Re: Initial Submission Review – Highline Village Subdivision Filing No 3 – Plat Amendment
Application Number: **DA-2228-00**
Case Number: **2020-3013-00**

Initial Submission Review

HIGHLINE VILLAGE

LA□D□CAP□
D□TAIL□

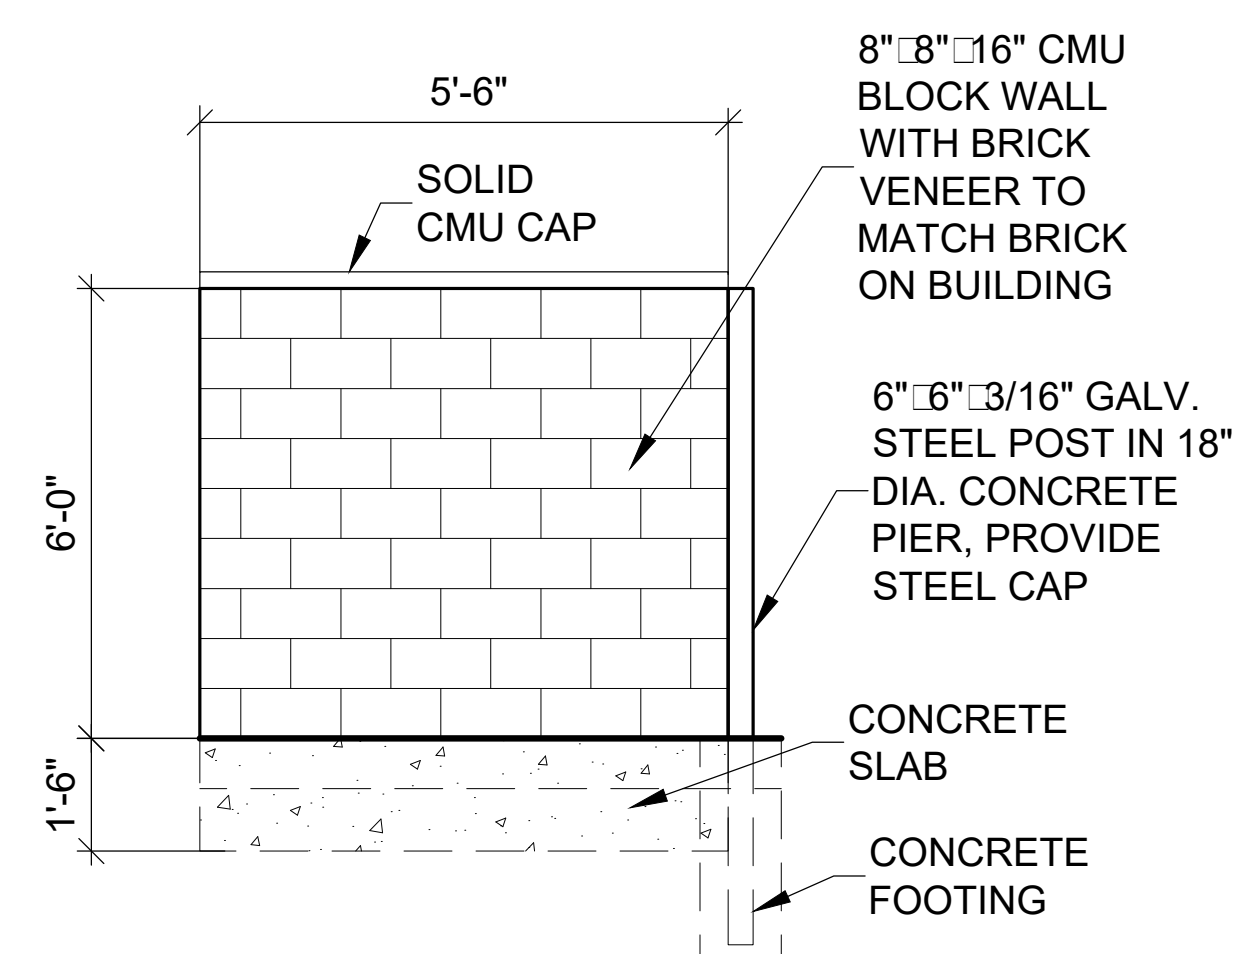
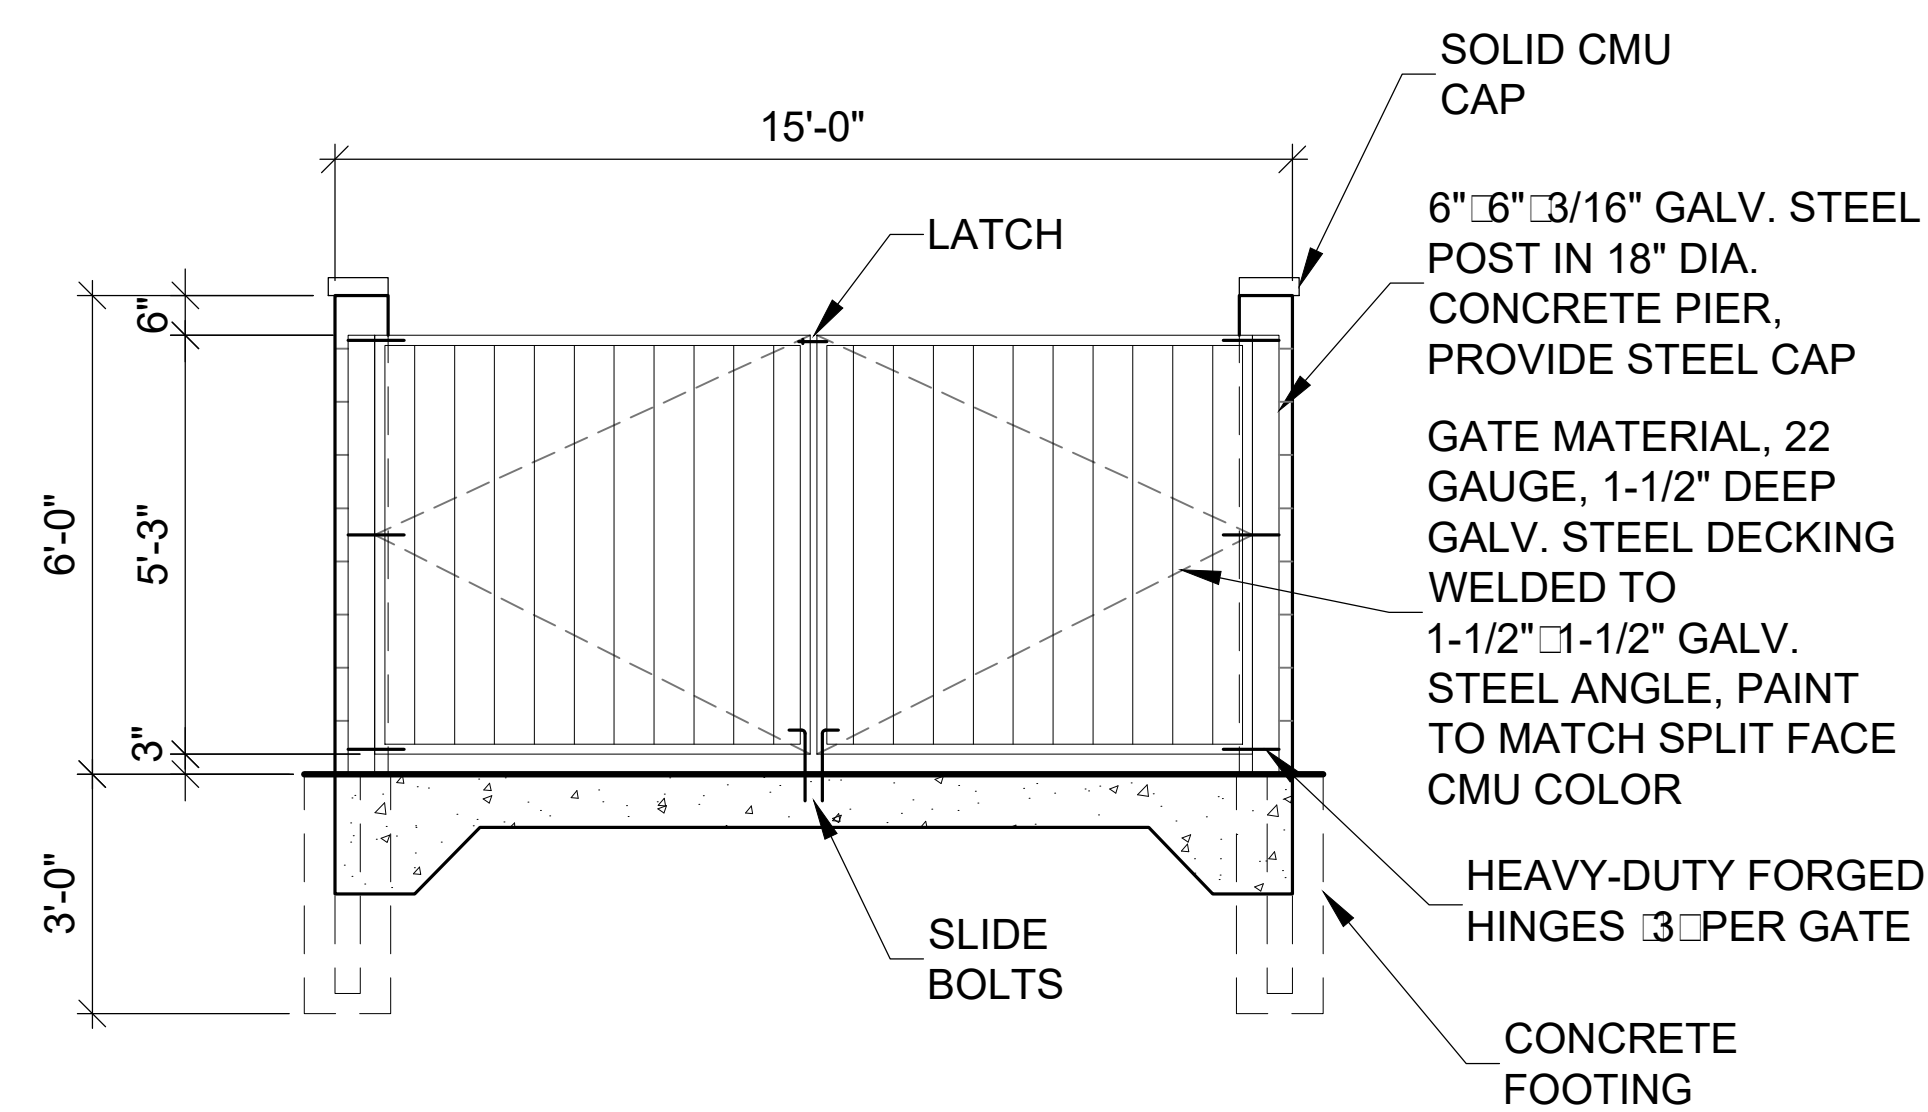
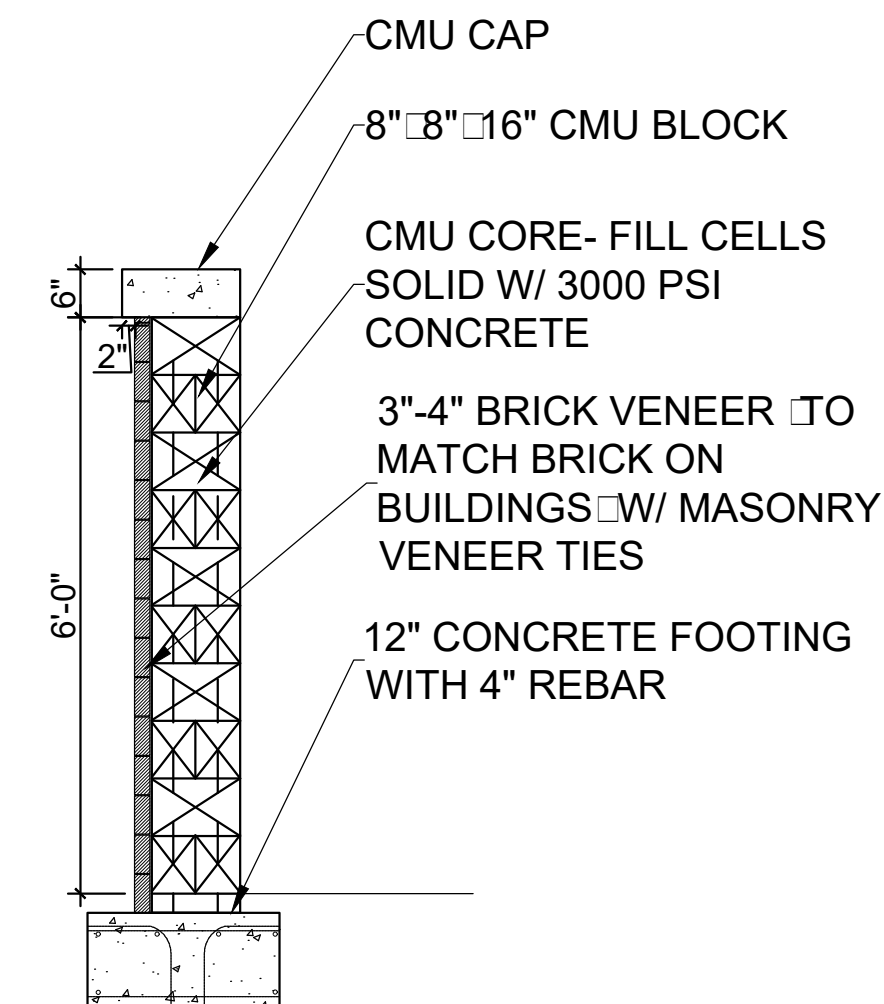
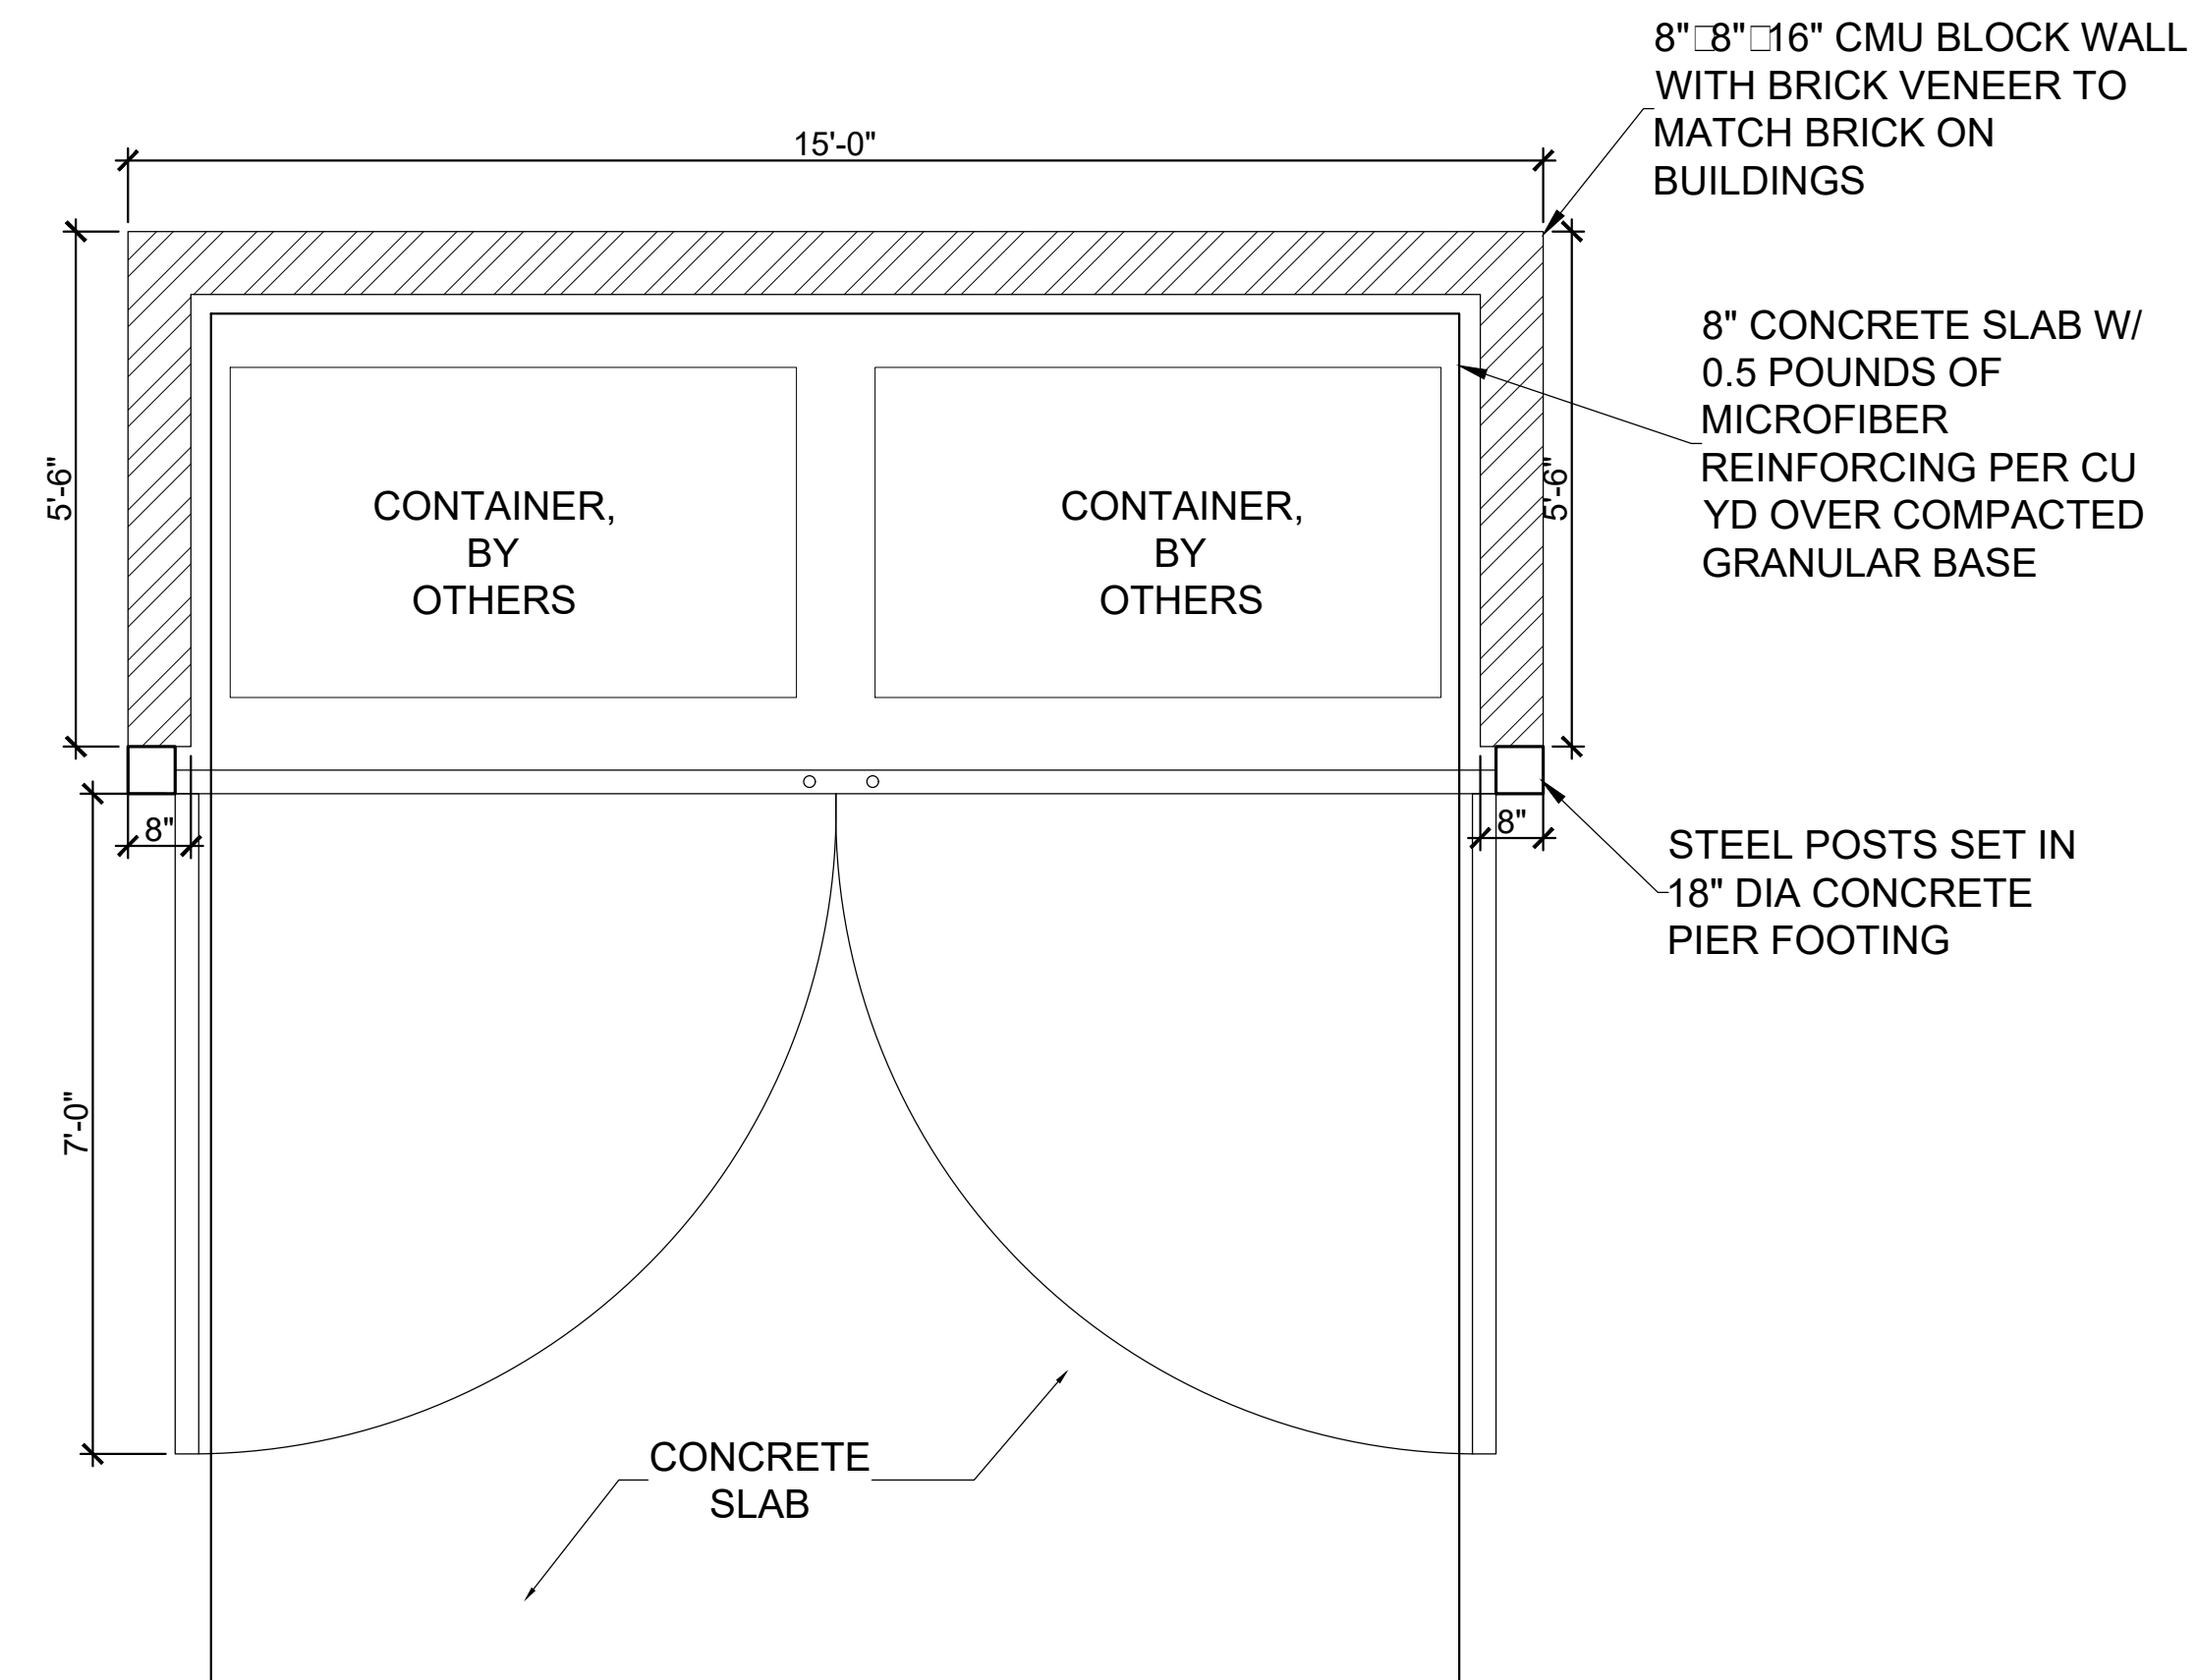
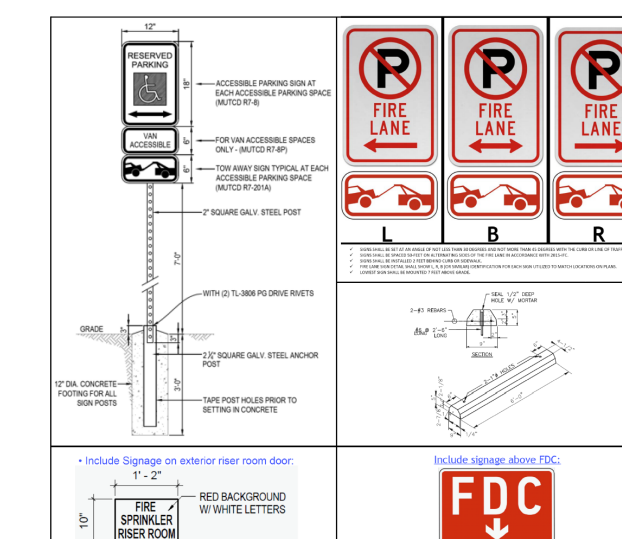
Include a section of the retaining wall

Provide a detail of your mail kiosks on this sheet.
Provide enough detail to reflect the accessibility
requirements of sidewalks to meet ICC A117.1.

Provide sign package detail. See below for reference.
